Table of Contents for Carpenter Hall Site Plan
Heritage Tree Variance Package

ITEM FOR ENVIRONMENTAL COMMISSION AGENDA

SITE PLAN #: SP-2016-0073

SITE PLAN: The Carpenter (SP-2016-0073C)

EXHIBIT A EXISTING CONDITIONS

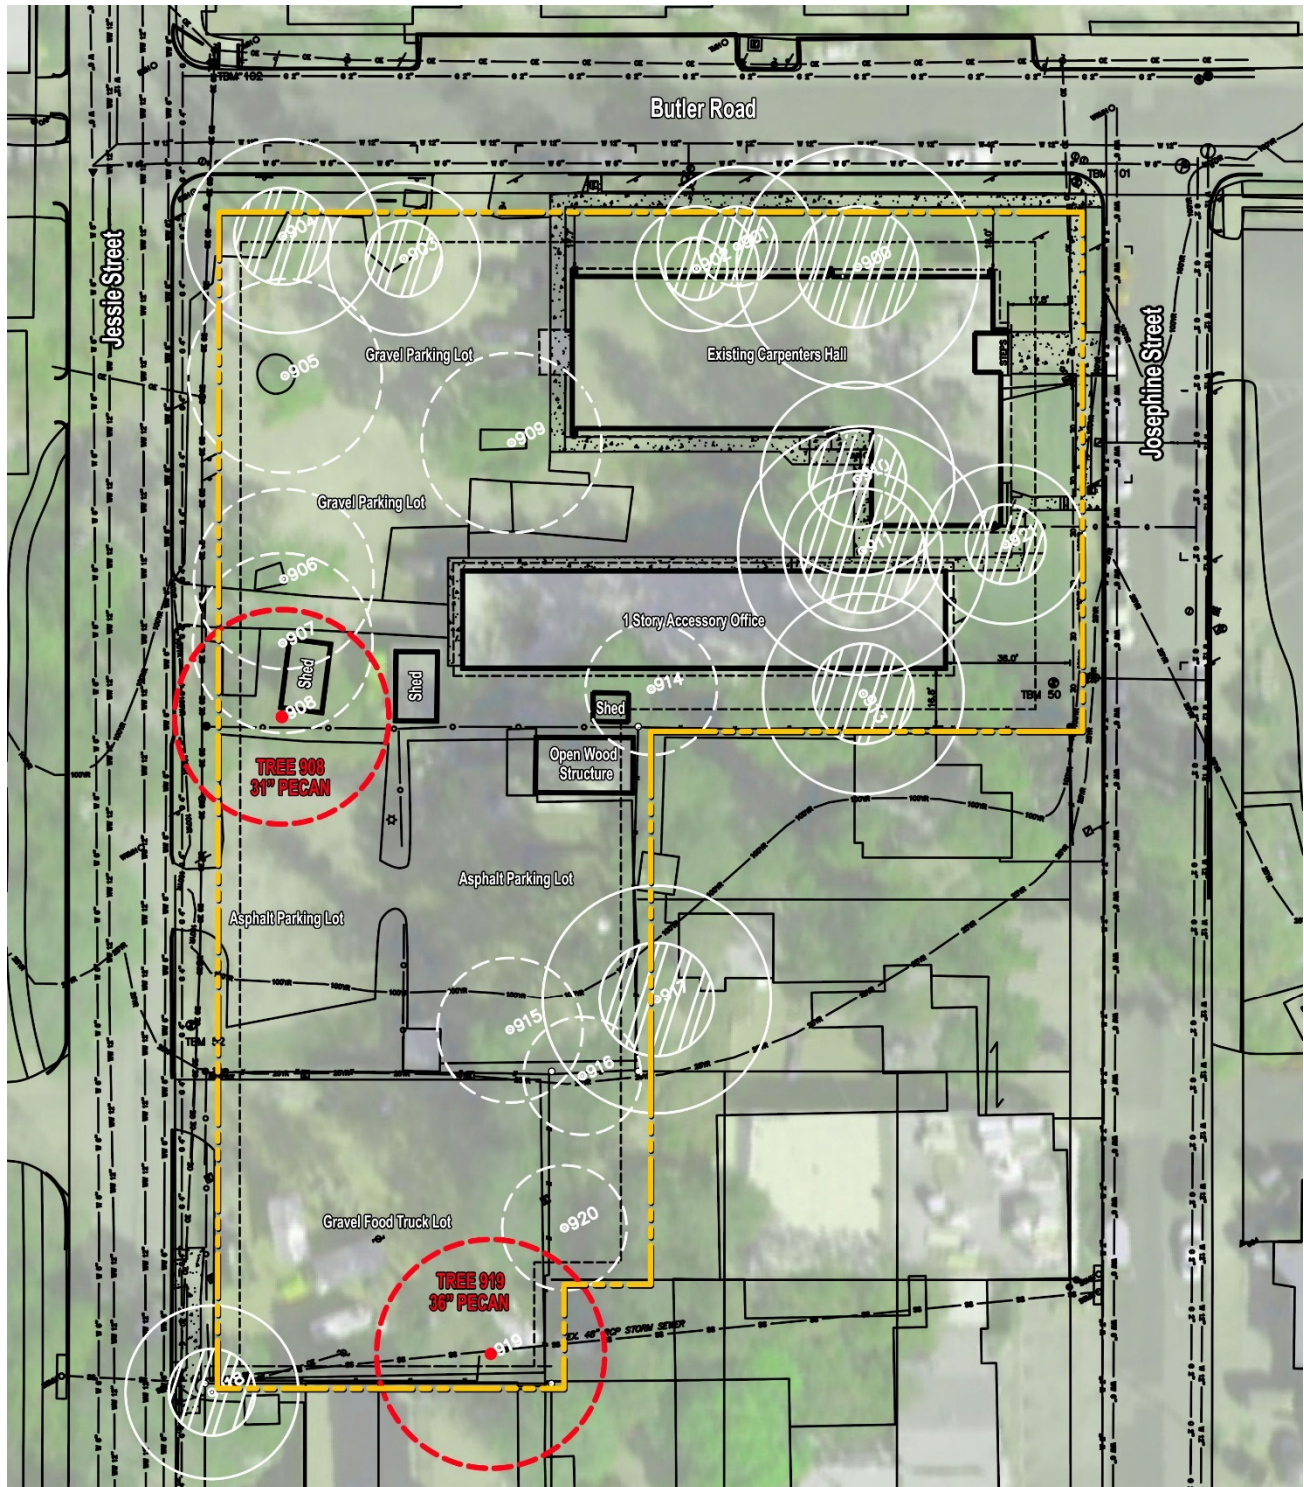
There are currently two heritage trees on the site being requested for removal, (1) 31" Pecan and (1) 36" Pecan (EXHIBIT A).

The property consists of 1.390 acres (60,527 square feet) and is zoned General Commercial Services (CS) (EXHIBIT A). The developable area is limited due to the preservation of the Carpenters Hall, existing heritage trees on and off site, and the zoning height restriction of sixty feet. The site is also required to comply with Subchapter E requirements controlling the placement of the proposed building and driving the request for removal of tree 908.

EXHIBIT B PRELIMINARY SITE PLAN

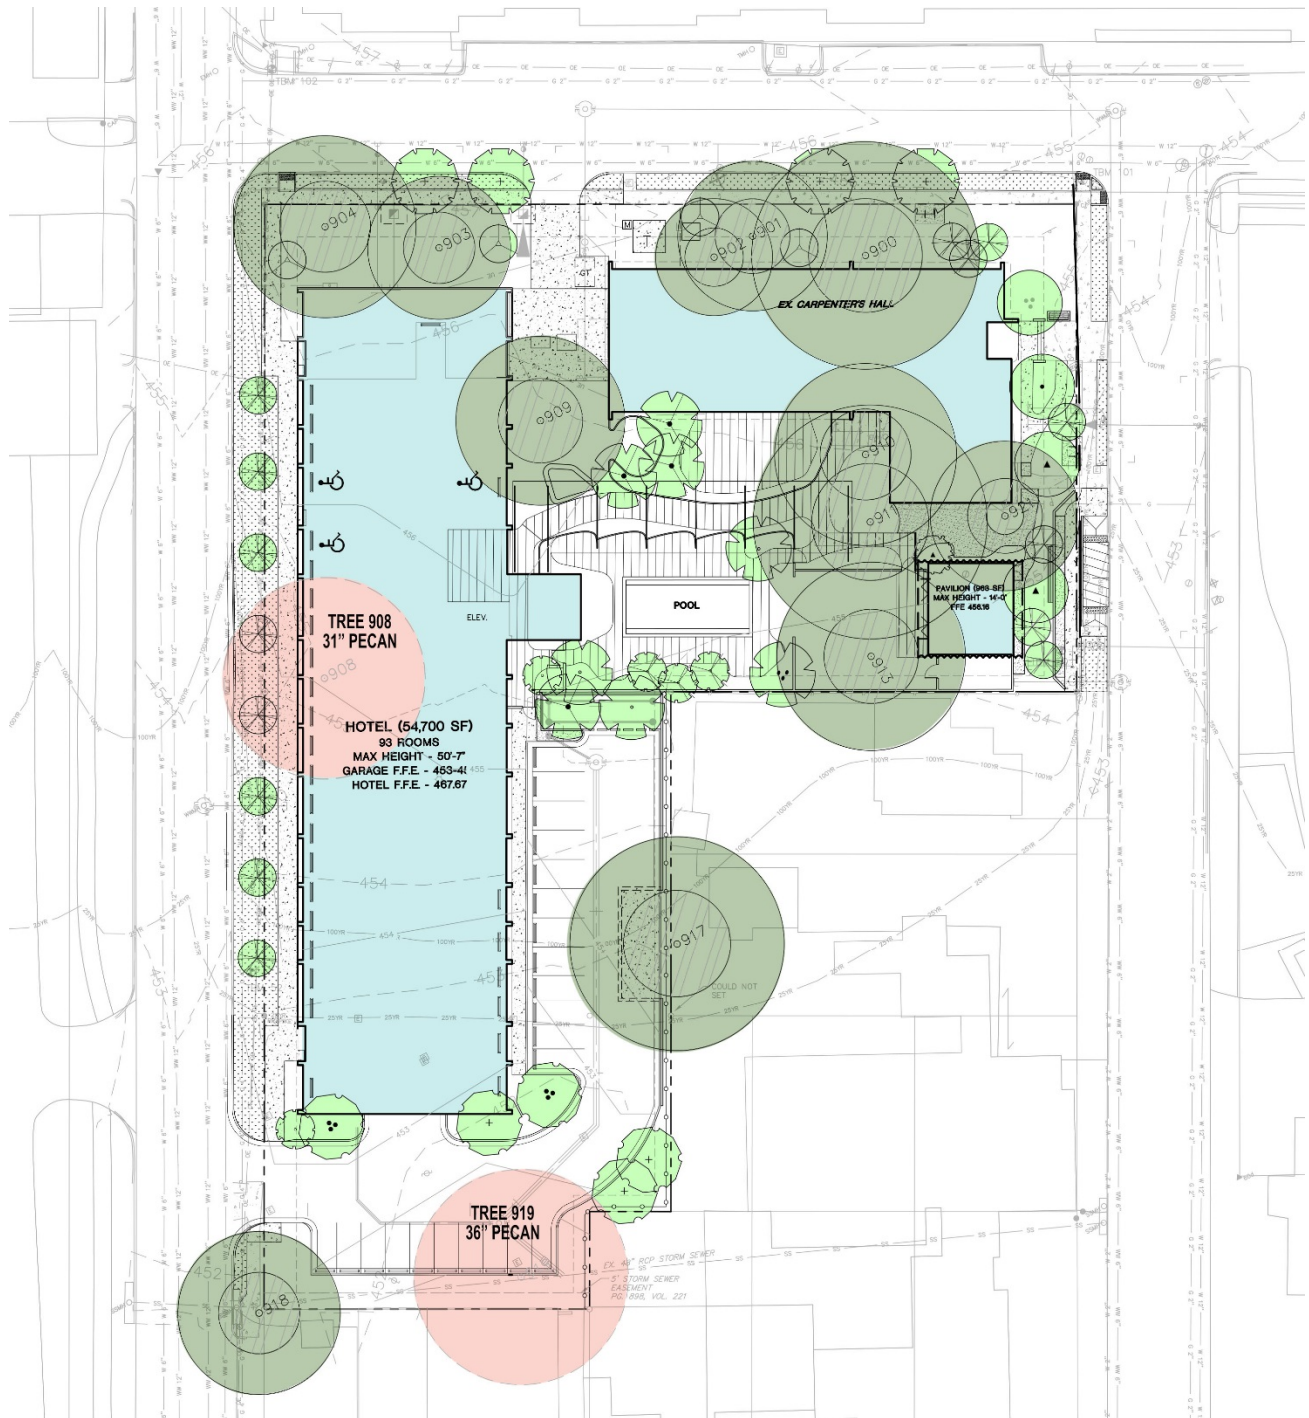
Tree 908, a 31" Pecan, depicted on (EXHIBIT B), is being requested for removal based on the limitations of how the site can be developed, and its potential risk to the public.

Tree 919, a 36" Pecan, depicted on (EXHIBIT B), is being requested for removal based on the condition of the tree, and its potential risk of causing personal injury, property damage, or both.

The original siting of the new building preserved tree 908 and 919. However, due to Subchapter E standards for sidewalks and building placement, the structure had to be placed directly in the path of tree 908 and the subsequent shift in parking impacted tree 919.

Tree #908: West stem tomograph near crotch at 9.5 feet above grade showing 31% decay

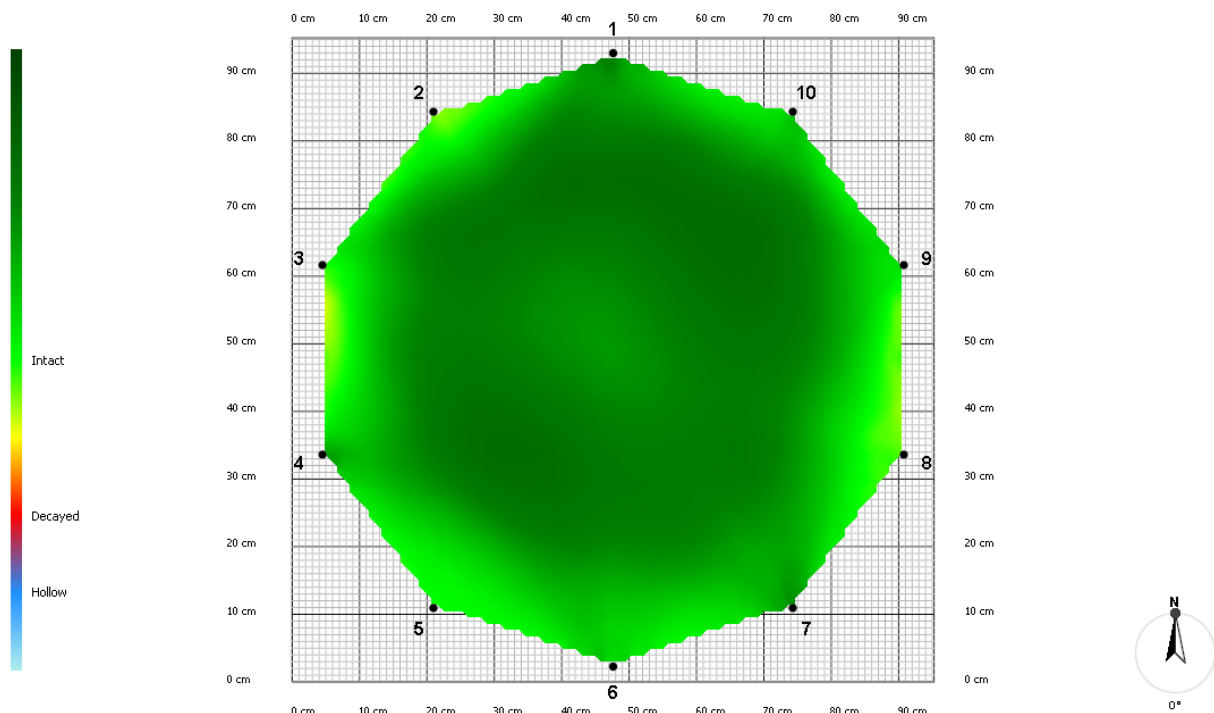
Response: Tree 908 has been assessed to have decay along the west stem and this part of the tree especially is of concern. The load of this stem is significant and the likelihood of failure for this tree part is probable. The overall risk rating for this tree is considered moderate (EXHIBIT C).

Regarding the west stem in particular, while solid wood appears mostly to surround the decay column, the decay does connect to the exposed cavity, which is large. This condition makes it likely that the decay will increase faster than wound closure. The location of this decay just above the crotch of the main stem also creates concern. The load on the west stem is *significant*, and the likelihood of failure for this tree part is *probable*.

- Remove the west stem.
- Prune the remaining tree to reduce weight at branch ends and to clean the canopy of dead branches one inch in diameter and greater.
- Install support cabling in the upper third of the canopy to provide mechanical support to weak branch unions to reduce risk of failure.
- Aerate the soil within the entire CRZ with a specialized tool, such as an Airspade, to reduce compaction.
